PERTH, FRIDAY, 9 SEPTEMBER 2005 No. 171 SPECIAL

**ELECTRICITY INDUSTRY
(WHOLESALE ELECTRICITY
MARKET) REGULATIONS 2004**

WHOLESALE ELECTRICITY MARKET RULES

AMENDING RULES

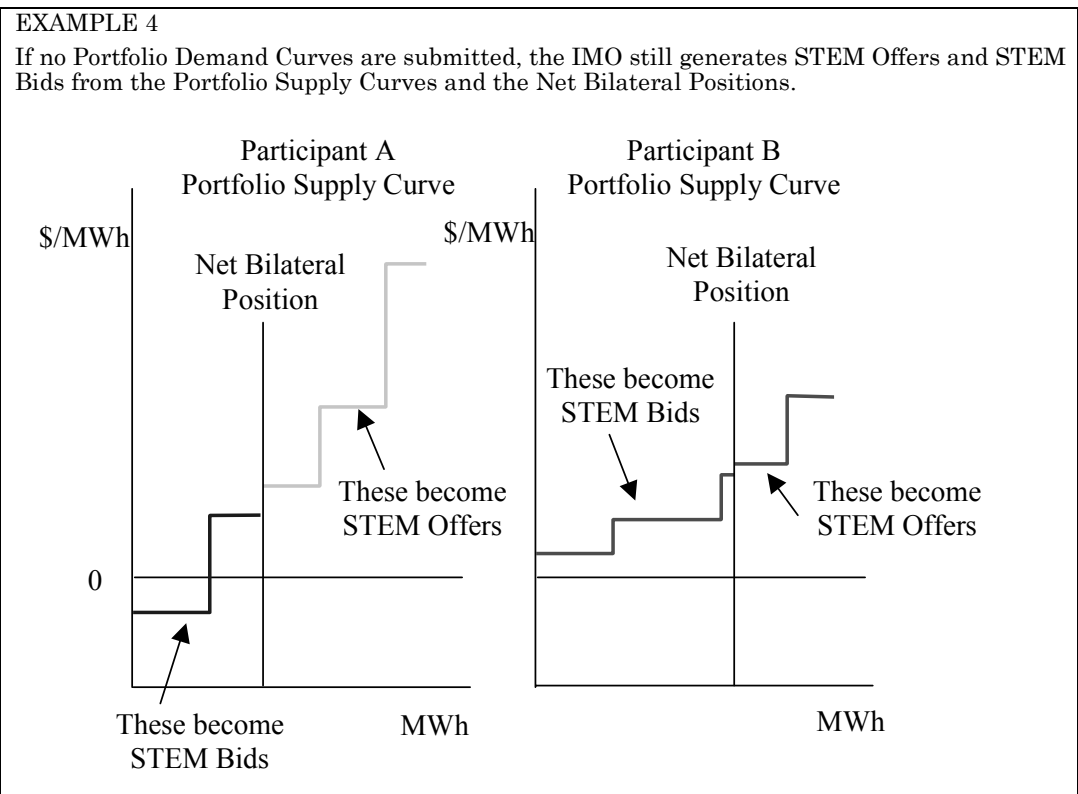
- (17) Delete the existing comment box for 6.6.11 and replace it with the following—

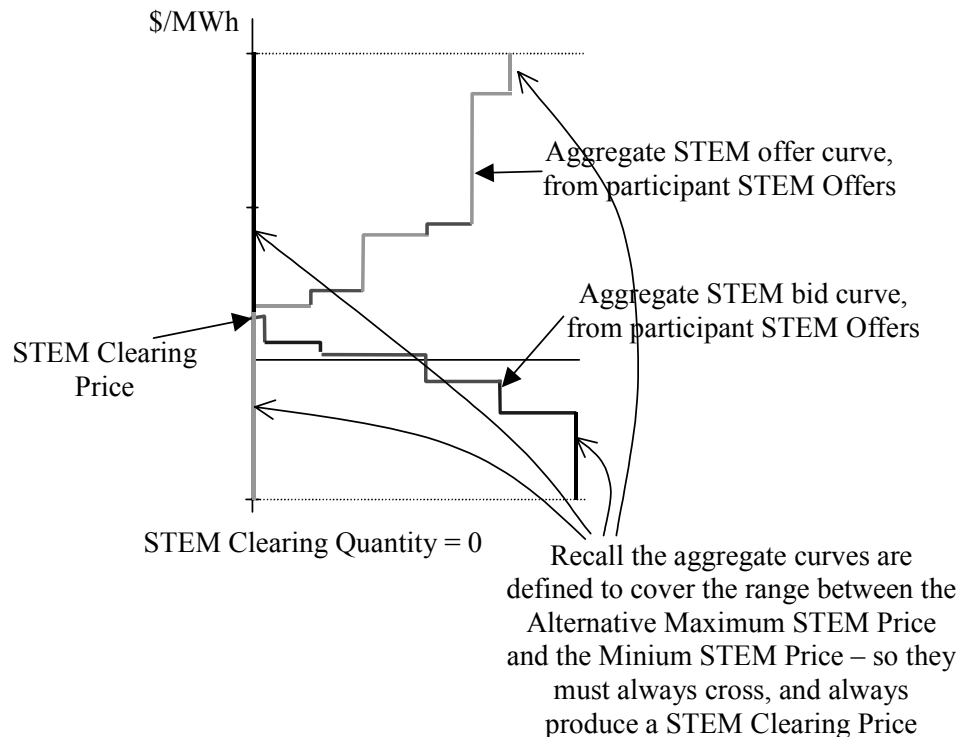
- (1) Delete the existing clause 6.9.3 and replace it with the following:
 - 6.9.3. Subject to clause 6.9.4, the IMO must determine STEM Offers and STEM Bids for each Market Participant for each Trading Interval in accordance with Appendix 6 using the valid STEM Submissions and Bilateral Submissions relating to that Trading Interval.
- (2) Delete the existing clause 6.9.4 and replace it with the following:
 - 6.9.4. Where the IMO has recorded in accordance with clause 6.3B.8 that a Market Participant has not made a STEM Submission for a Trading Interval the IMO must not determine STEM Offers, STEM Bids or MCAP Price Curves for that Market Participant in that Trading Interval.
- (3) Amend clause 6.9.8 by replacing the box text from “Example 4” with the following—

The IMO can clear the market using these generated STEM Offers and Bids. The diagram below shows the STEM being cleared.
